PRODUCT ADVISORY

**Part Marking Configuration Change for
Intersil Product IS9-705RH*
(DSCC 5962R0053801*XC)**

**Refer to:
PA10040**

Date: April 16, 2010

Marking examples:

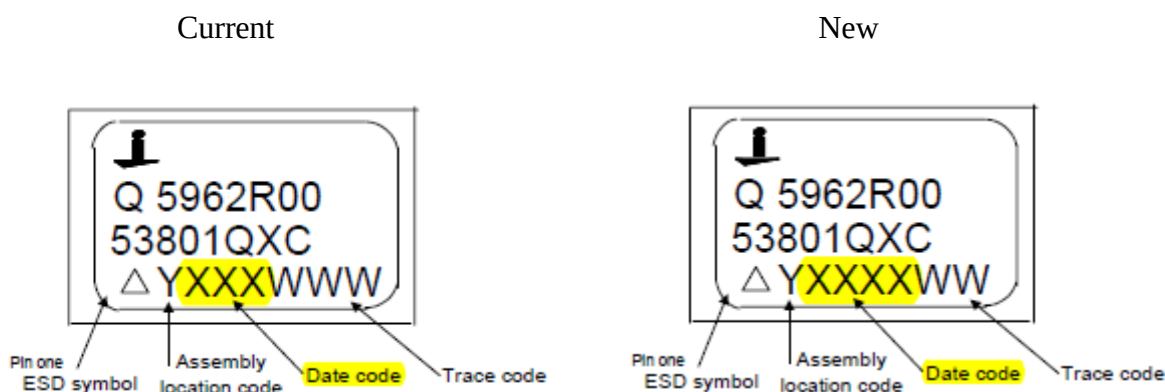
This advisory is to inform you that Intersil is changing the configuration of the “top side” marking (brand) for the listed IS9-705RH* (DSCC 5962R0053801*XC) products. The marking layout is being restructured to utilize a 4-digit date code (2-digit year plus 2-digit week) instead of the current 3-digit date code (1-digit year plus 2-digit week). The transition to the 4-digit date code format is necessary to eliminate confusion as to the year of product assembly (seal). This change will be implemented beginning with date code 1013.
